South Texas Project
Units 3 and 4
Docket Nos. 52-012 and 52-013
Response to Request for Additional Information

08.03.01-4, Supplement 3

08.03.01-6, Revision 1

FSAR Ch. 21 Figure 8.3-1 Sheet 3

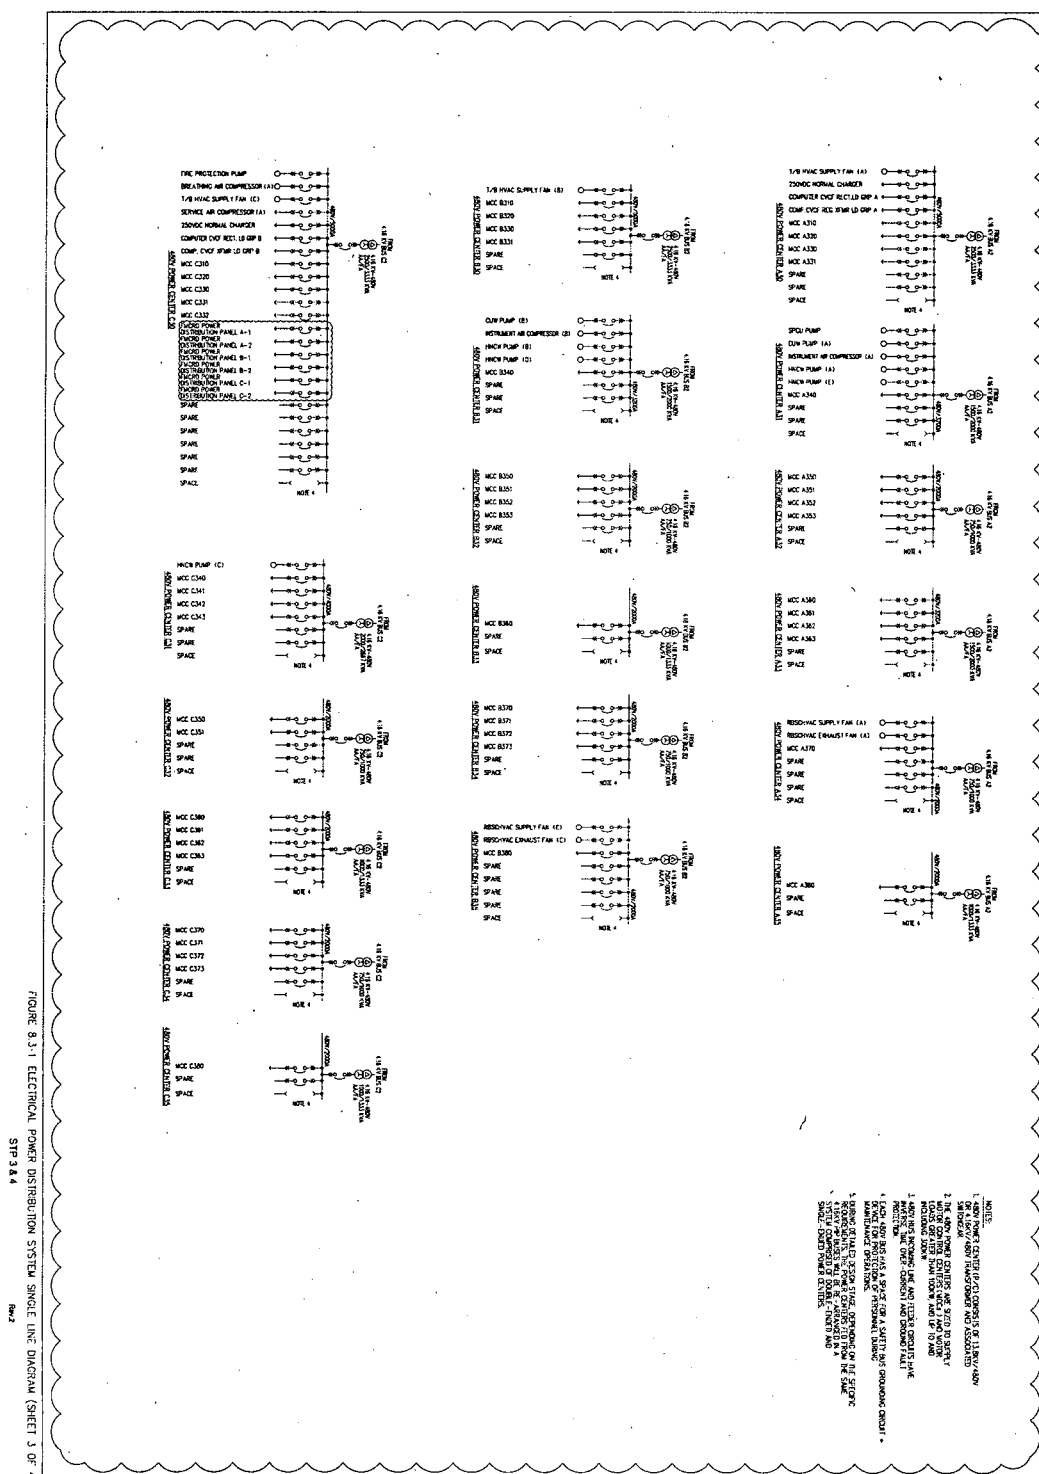
3. FSAR Figure 8.3-1, Sheet 4, shows feeds from Power Center E10 to the FMCRD Power Distribution Panels. These figures show there are two isolation devices in series for the feeds from Power Center E10 to the FMCRD Power Distribution Panels.

The design minimizes the probability of a single failure affecting more than one FMCRD group by providing six-three independent Class 1E feeds (two-one for each group) directly from the Division 1 Class 1E 6.9 4.16 and PIP 480 kV buses (see sheet 3 sheet 3 and 4 of Figure 8.3-1).

The capability to power the FMCRDs directly from a PIP bus and the direct transfer capability is changed to occur at the 480 volt level. These changes are reflected in FSAR Sections 8.3.1.1.1, Figures 8.3-1, Sheet 1, 3 and 4 and FSAR Table 9A.6-2 Fire Hazard Analysis.
